RE: SIRSI MARINA, NEWPORT - NAVIGATION IMPACT ASSESSMENT ADVICE

RE: SIRSI MARINA, NEWPORT - RESPONSES TO DPI-FISHERIES MATTERS

Further to recent correspondence, it is understood that initial feedback on the marina proposal has been received from DPI-Fisheries who have identified several matters to be addressed in an updated Aquatic Ecology Assessment (AEA), to be prepared by Ocean Environmental.

Figure 1: Aerial photo overlay of proposed marina layout

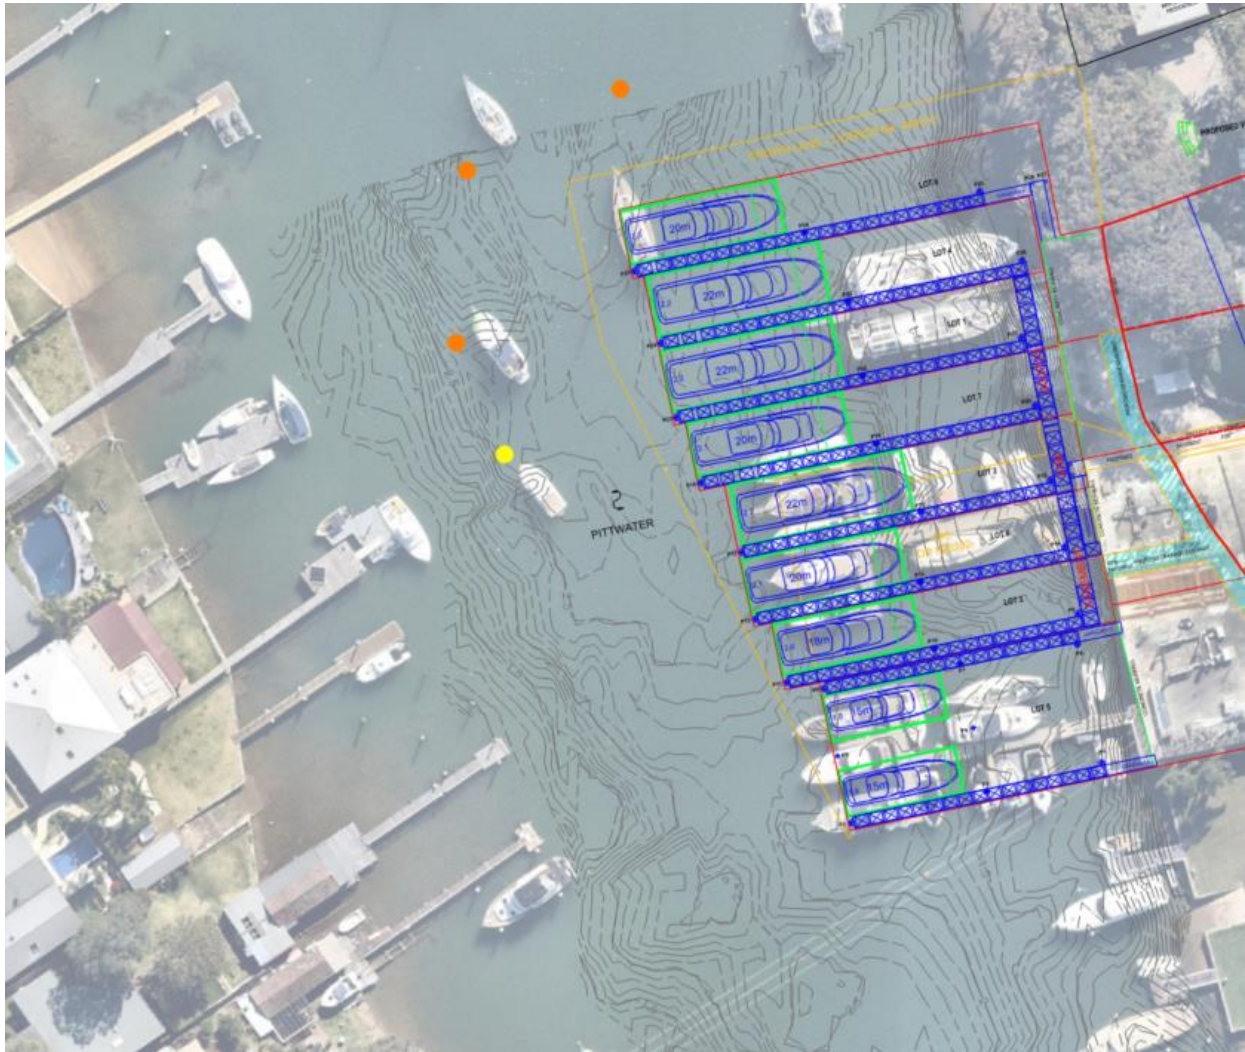
We note that the site is located within a shallow, narrow bay. Given the facilities proposed, we suggest that the AEA determines whether these would change hydrology or e-folding time within the bay and if so, whether this would adversely affect water quality and marine ecology within the bay.

In the vicinity of the proposed marina upgrade, Winji Jimmi Bay has a waterway width of around 110-120m and water depths increase from the shallow foreshore areas to a maximum depth of approximately 2.5-3m below Chart Datum (which represents the water level of the lowest astronomical tide).

The aerial photo overlay of the proposed marina layout shown in **Figure 1** below indicates that the upgraded marina would have similar or reduced encroachment into the waterway and lower vessel berthing density along the southern five berths when compared to the existing marina facility. The waterway encroachment of the northern four berths would be similar to that of the southern portion of the existing and upgraded marina, and vessel berthing density would be similar to that of the existing marina facility with single vessels of up to 22m length occupying each individual berth.
